Date Created : **2008/04/08**
Date Issued On : **2008/04/17**
PCN# : **Q2081501**

INFORMATION ONLY NOTIFICATION

Change Type Description: Package External Dimension

TO252/TT252 MARKETING DRAWING

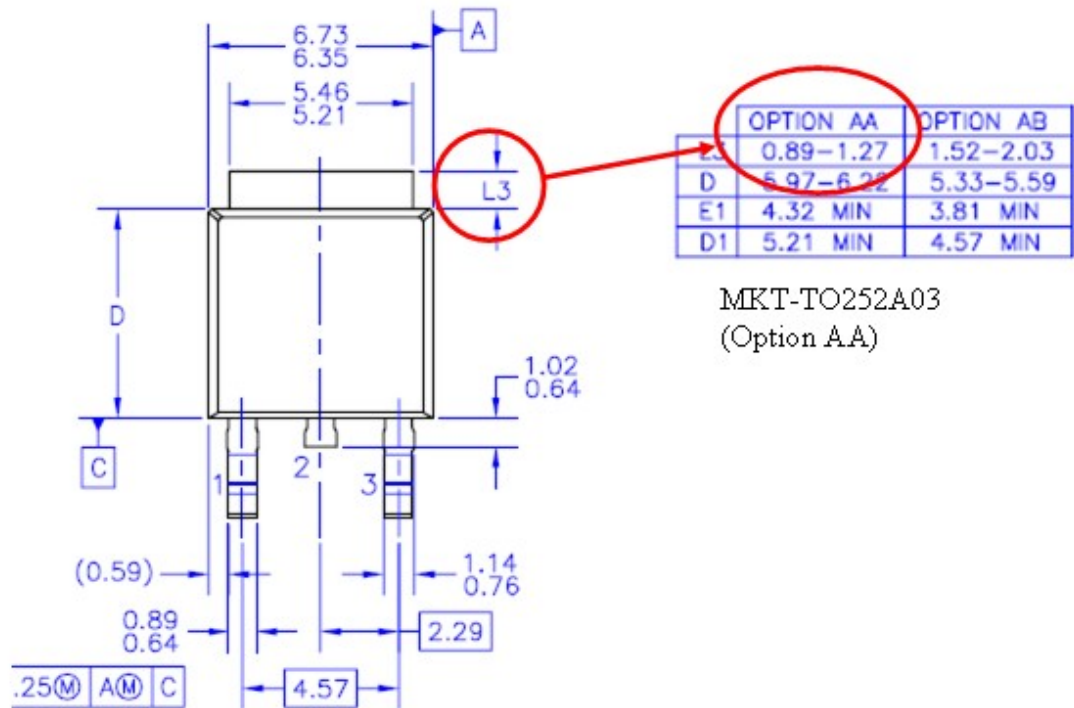
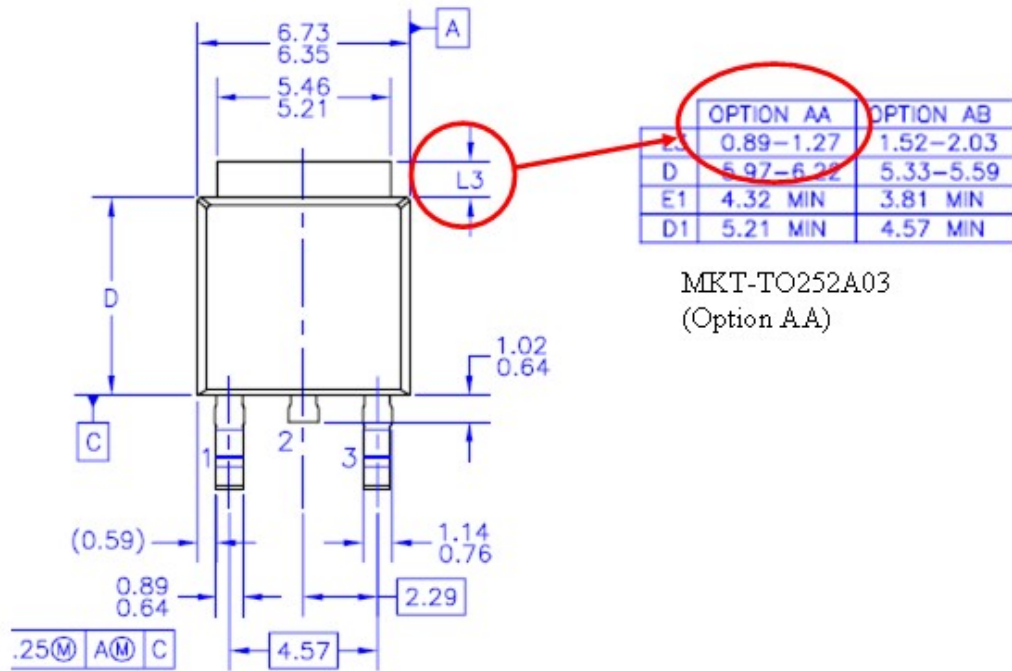
Description of Change (From): Dpak with heatsink protrusion and Dpak with flat heatsink are not combined in one reel per lot.

Description of Change (To): Dpak with heatsink protrusion and Dpak with flat heatsink will be combined in one reel per lot. The heatsink dimensions are within marketing specs.

Current DPAK 3 rows
Heat sink sides has protruding angles

DPAK 4 rows
Heat sink side is flat
